**KENDALL COUNTY
STORMWATER MANAGEMENT OVERSIGHT COMMITTEE
PUBLIC HEARING**

1. **Petition 24-15 Kendall County Forest Preserve District**

Meeting Type: Other Committee
Meeting Date: 6/18/2024
Subject: Approval of Petition 24-15, Stormwater Ordinance Variance for Subat Forest Preserve
Prepared by: Matthew H. Asselmeier, AICP, CFM
Department: Planning, Building and Zoning

Approval of Petition 24-15, A Request from the Kendall County Forest Preserve District for a Variance to Section 203 of the Kendall County Stormwater Management Ordinance Regarding Applicability of Site Runoff Storage Requirements at the Subat Forest Preserve Located at 4845 Eldamain Road, Plano (PINs: 01-25-400-009, 01-36-200-022, and 01-36-200-025) in Little Rock Township

2 Boardwalk
SCALE: 1" = 1'-0"

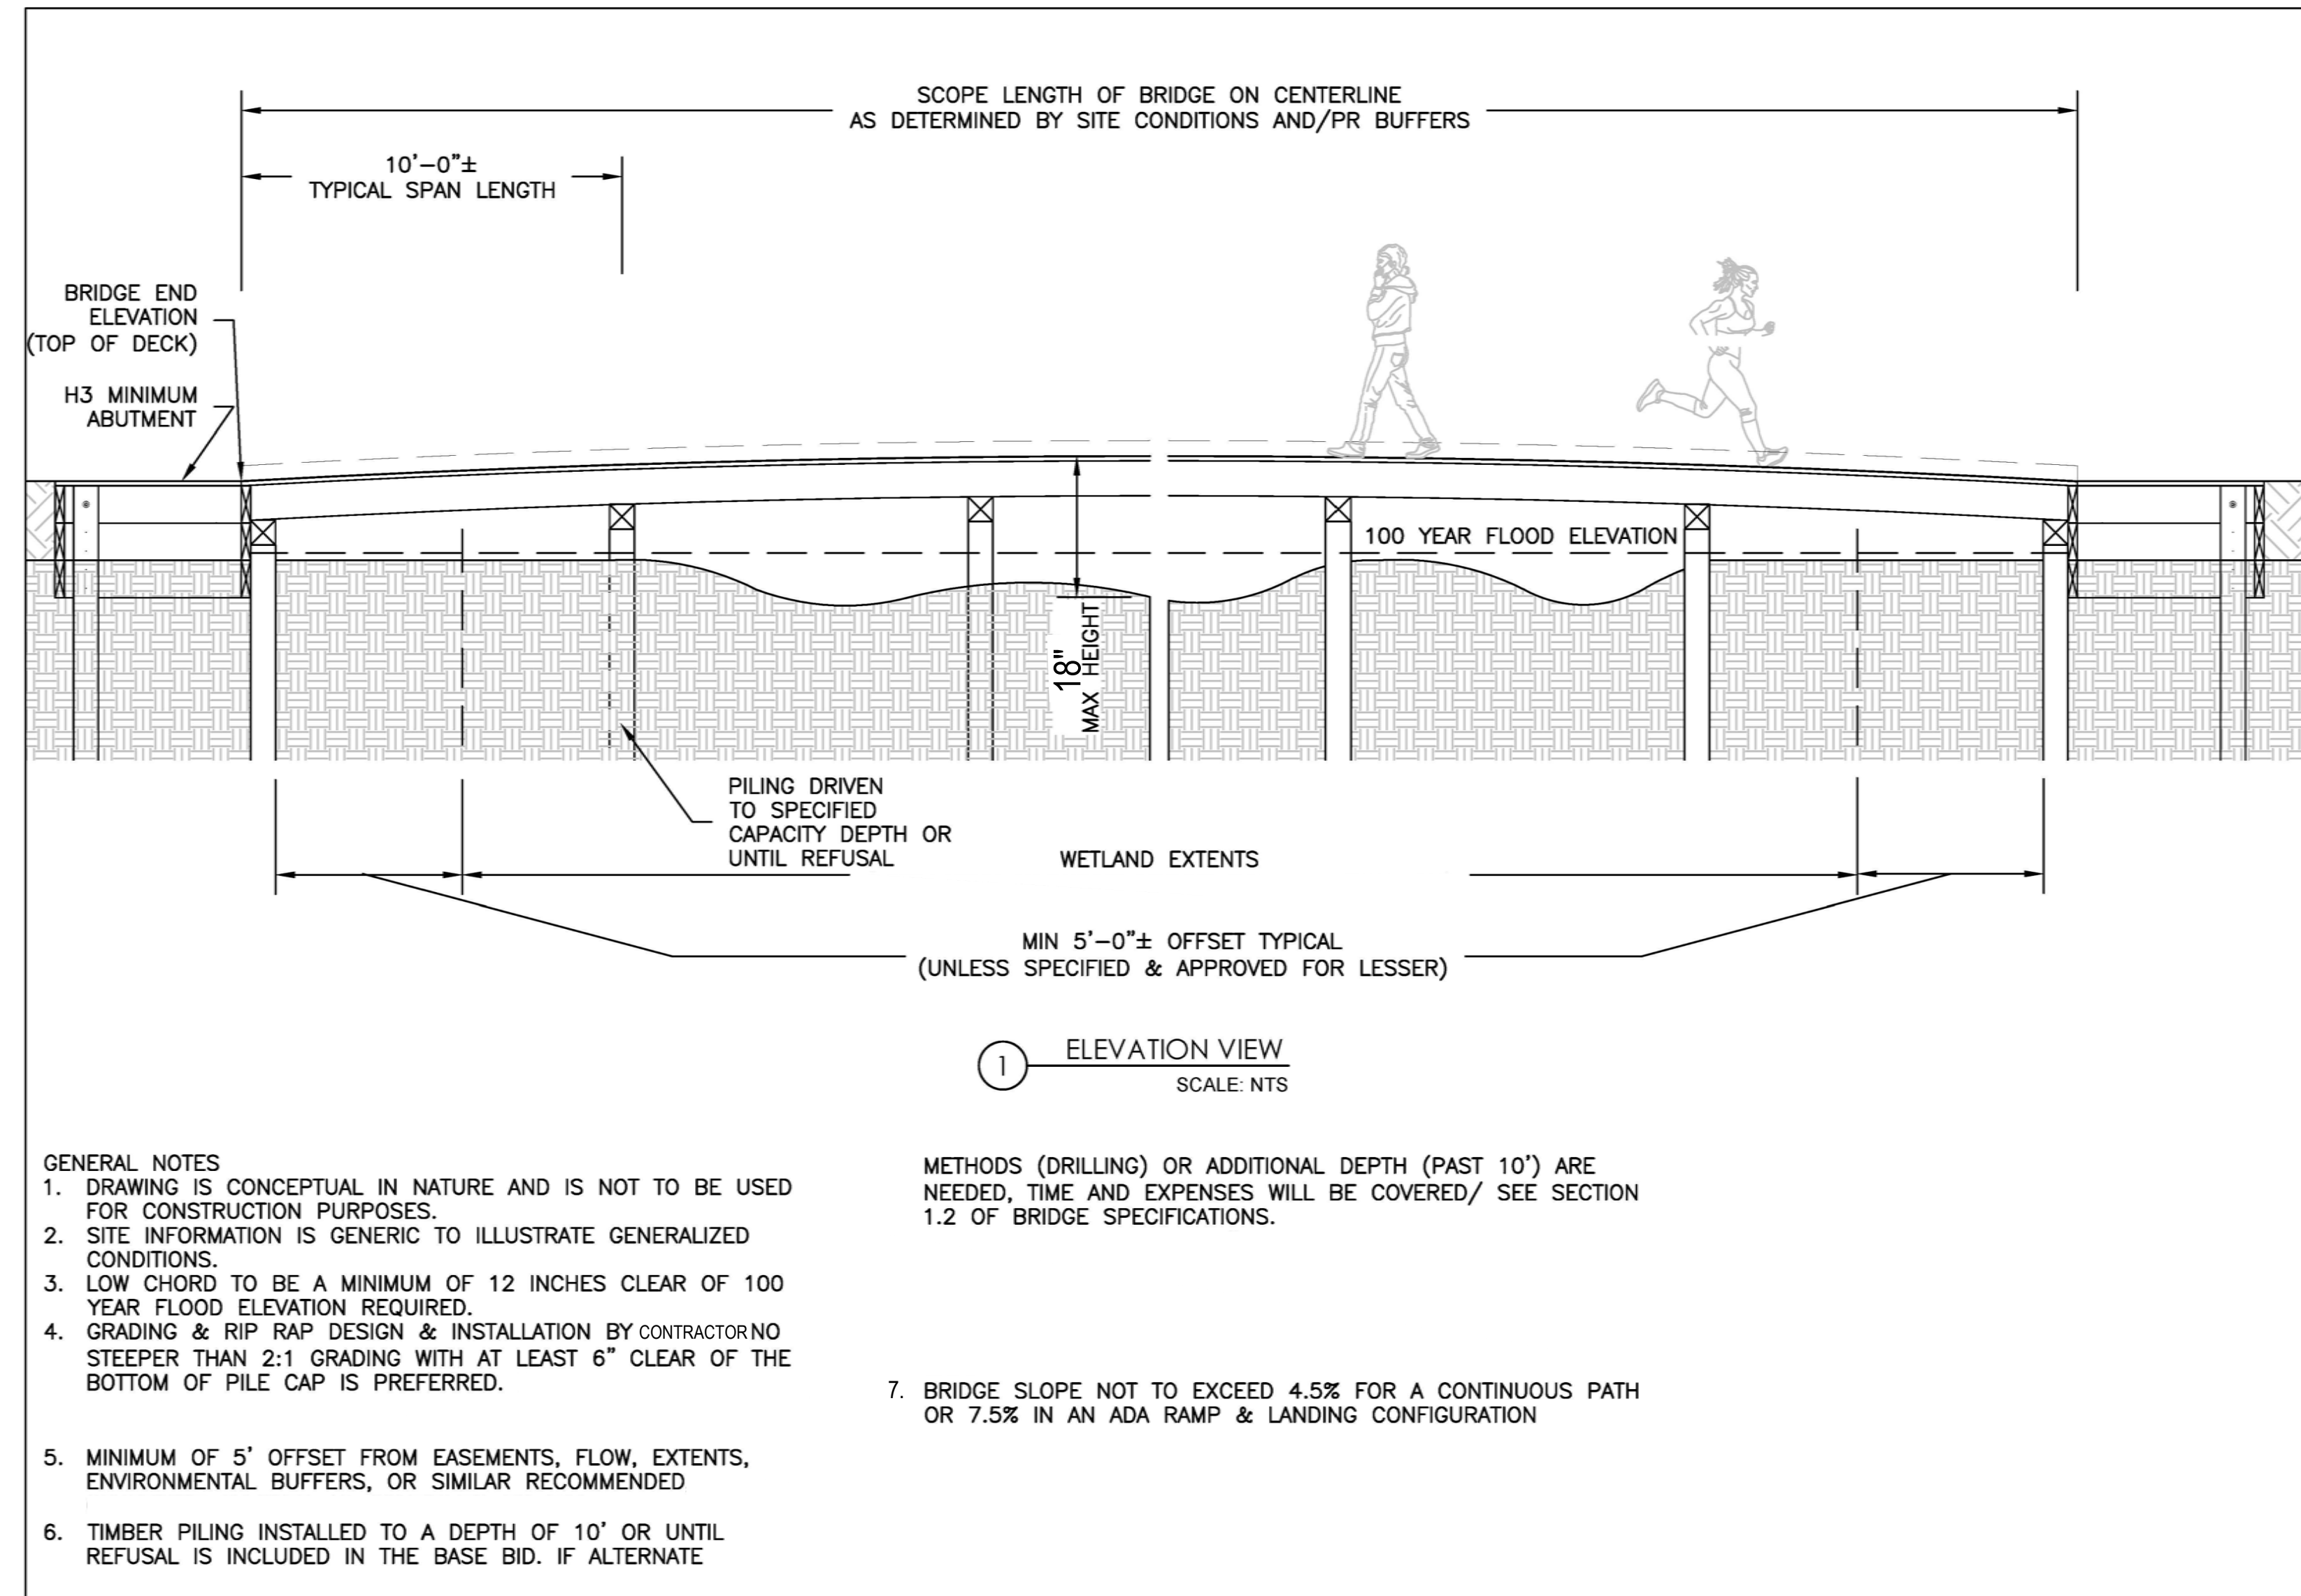
1. Stormwater report – The boardwalk spans a significant drainageway with an upstream area that appears to exceed one square mile. While this is not floodplain please verify the boardwalk will not have an adverse impact on Eldamain Road. (See attached Streamstats Rreport)
2. We have no objections to access to Eldamain Road. Please verify Kendall County Highway Department concurrence.
3. L401 – Verify adequate cover over the 12 “RCP at the northernmost access to Eldamain, Revise as necessary.
4. L501 – The Boardwalk detail depicts the 100 year flood elevation. We concur with the concept presented in the detail. Provide the 100 flow elevation as well as the basis for determining that elevation at the boardwalk.
